TITLE: Block Manager Rev D		
Document Number:	REV:	
	Sheet: 2/2	
Date: 4/25/2016 6:17:50 PM

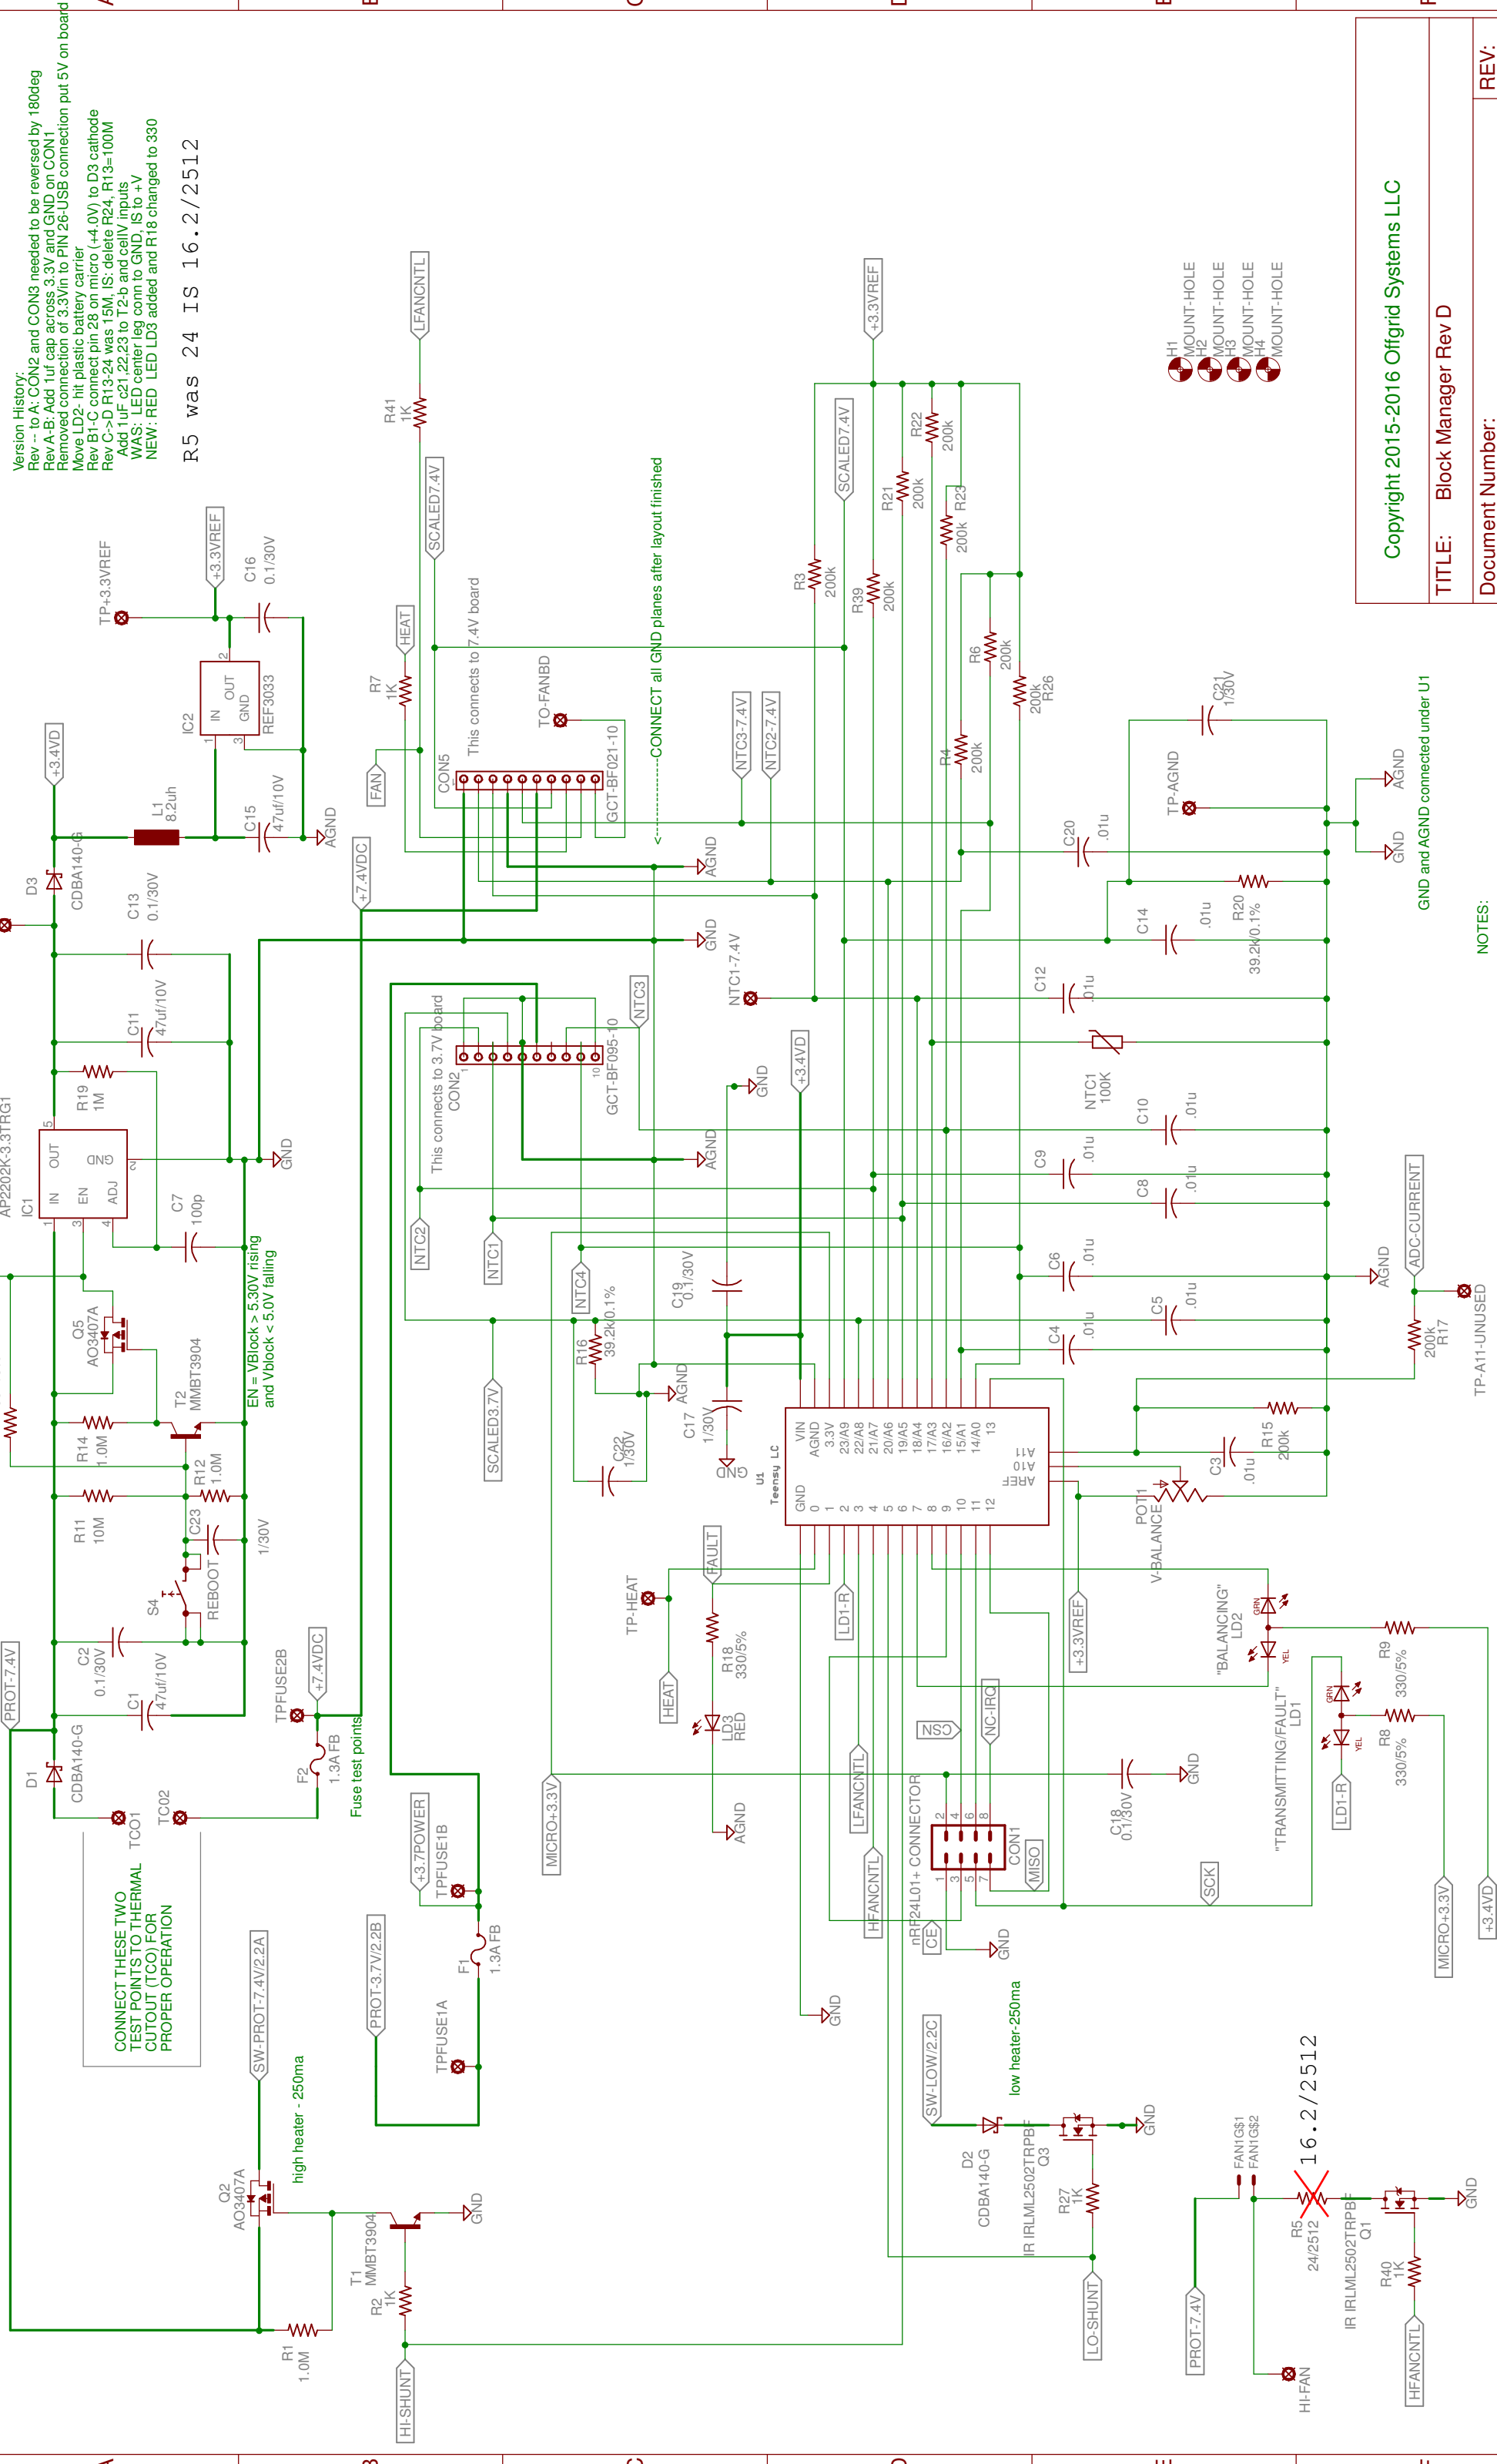
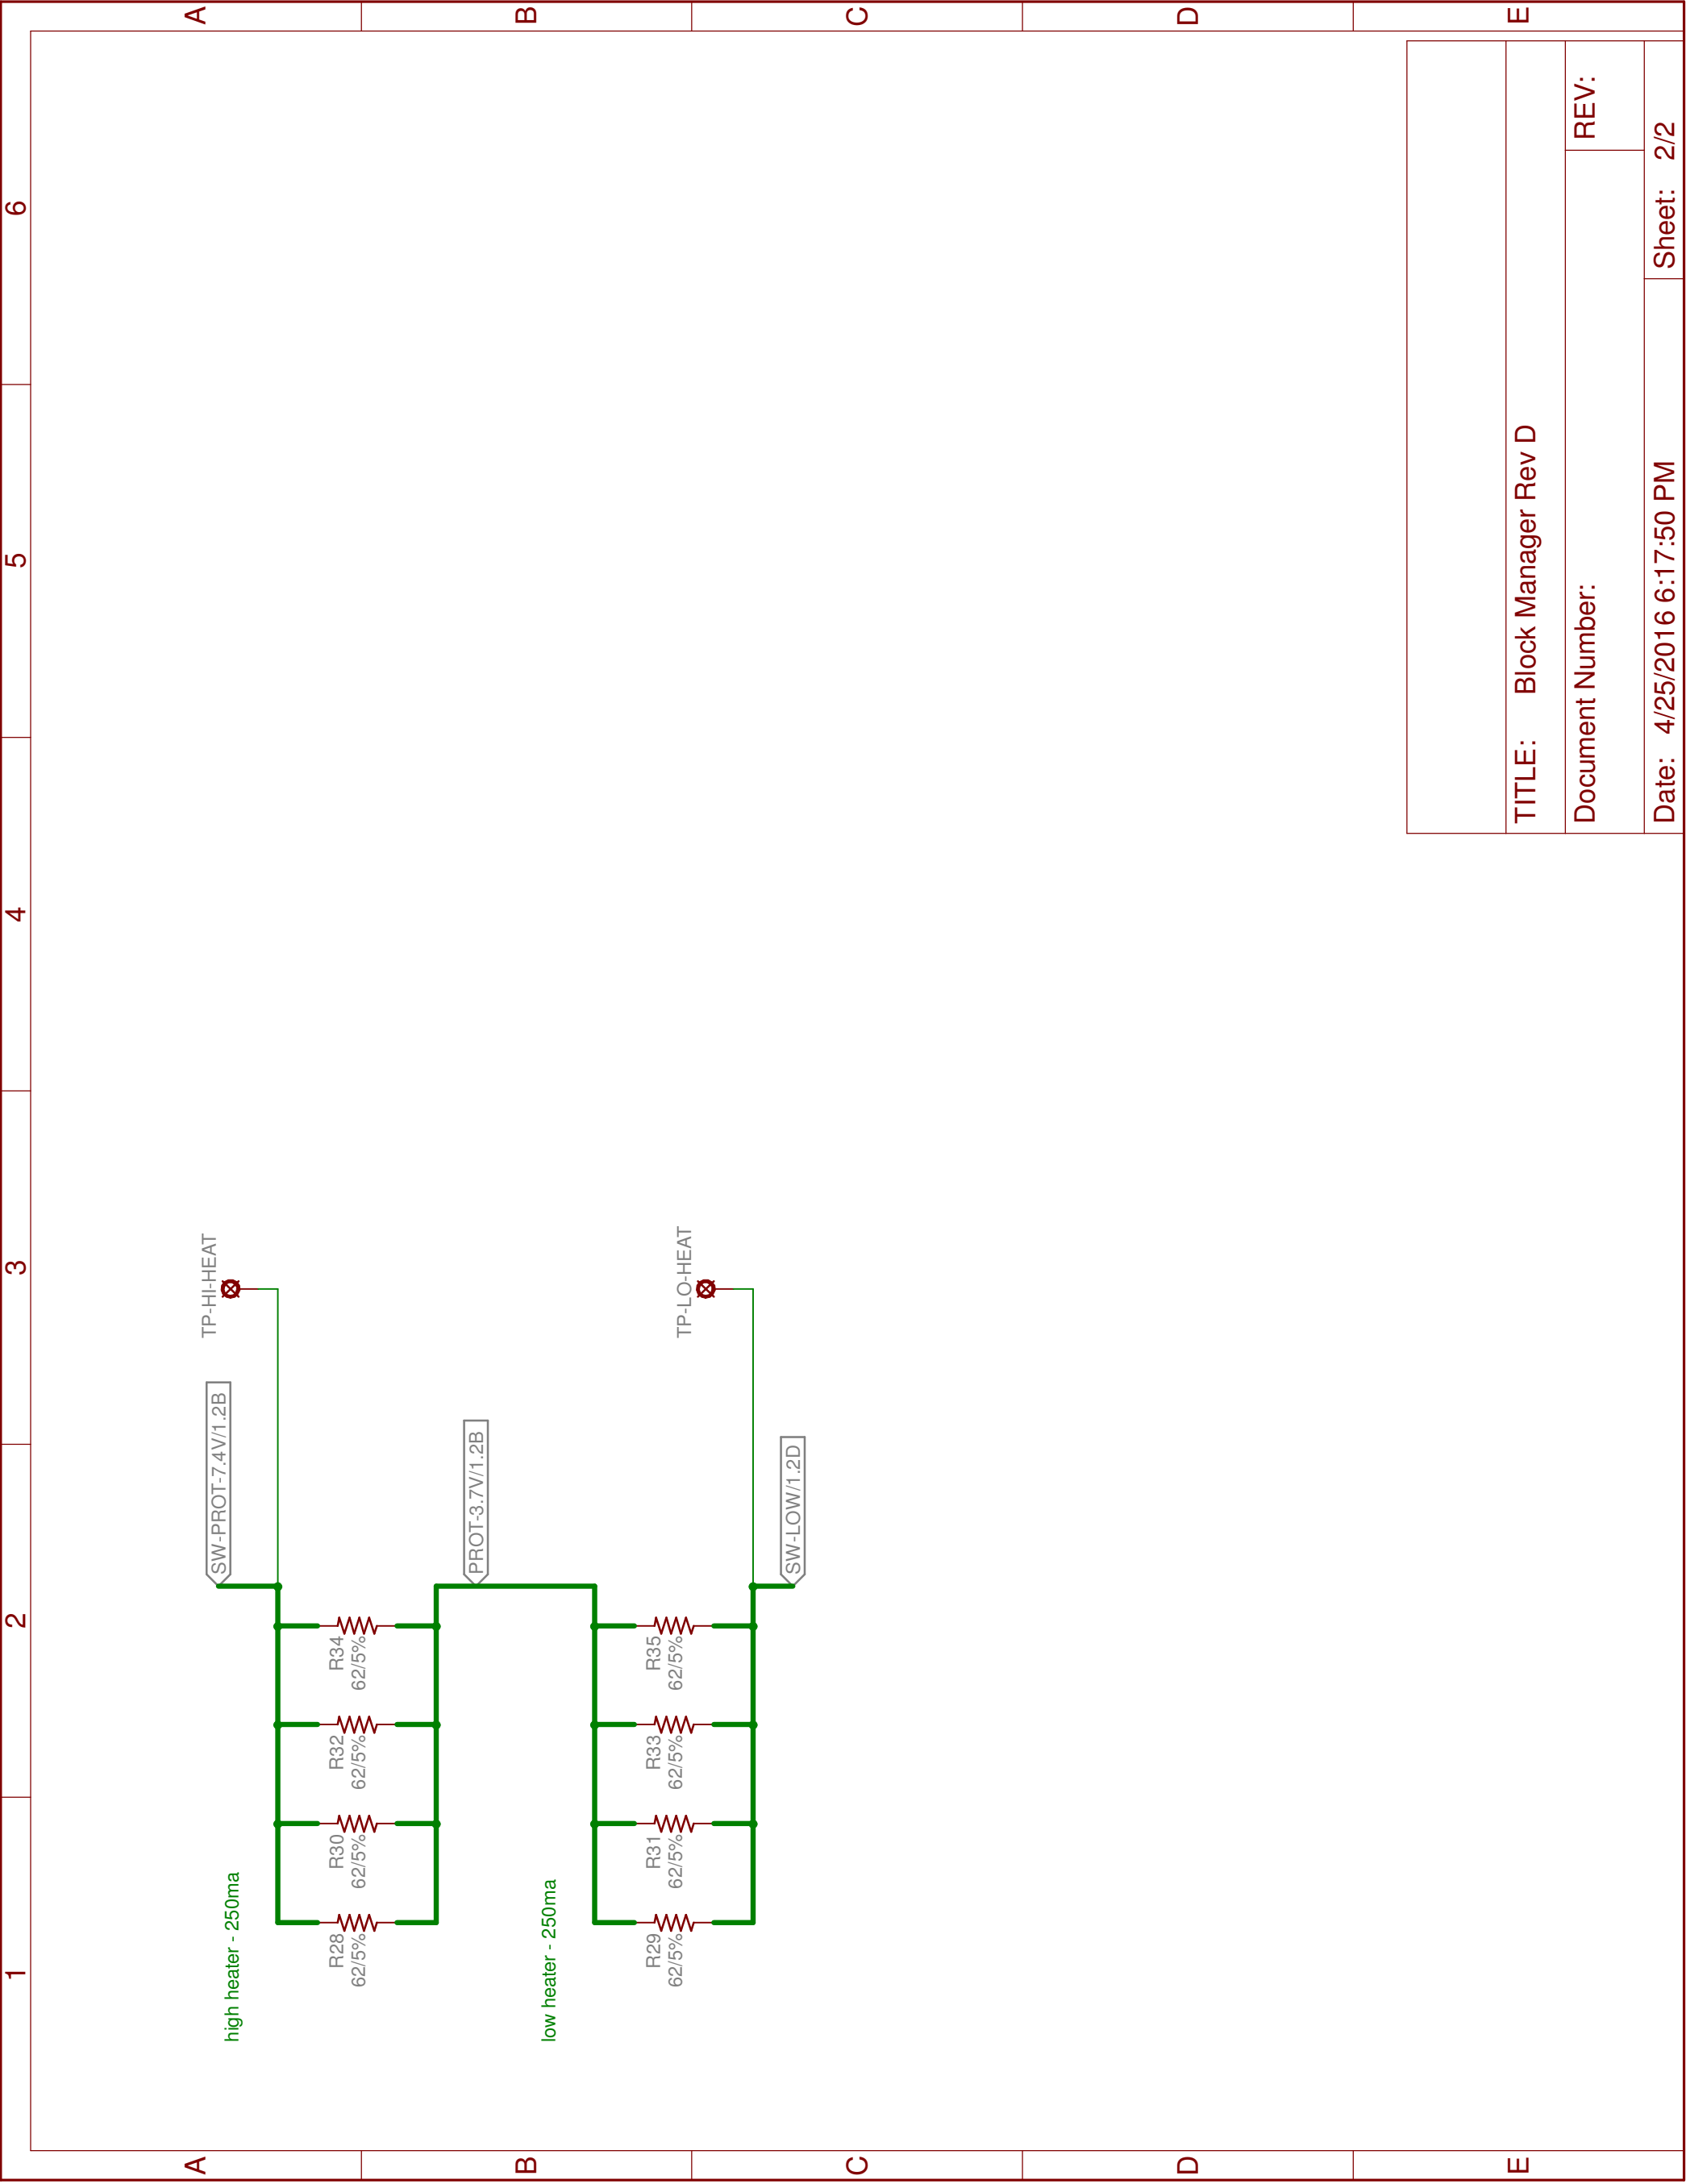
Version History:
Rev -- to A: CON2 and CON3 needed to be reversed by 180deg
Rev A-B: Add 1uf cap across 3.3V and GND on CON1
Removed connection of 3.3Vin to PIN 26-USB connection put 5V on board
Move LD2 - hit plastic battery carrier
Rev B1-C connect pin 28 on micro (+4.0V) to D3 cathode
Rev C->D R13-24 was 15M, IS; delete R24, R13=100M
Add 1uF C21,22,23 to T2-b and cellIV inputs
WAS: LED center leg com to GND, IS to +V
NEW: RED LED LD3 added and R18 changed to 330

R5 was 24 IS 16.2/2512
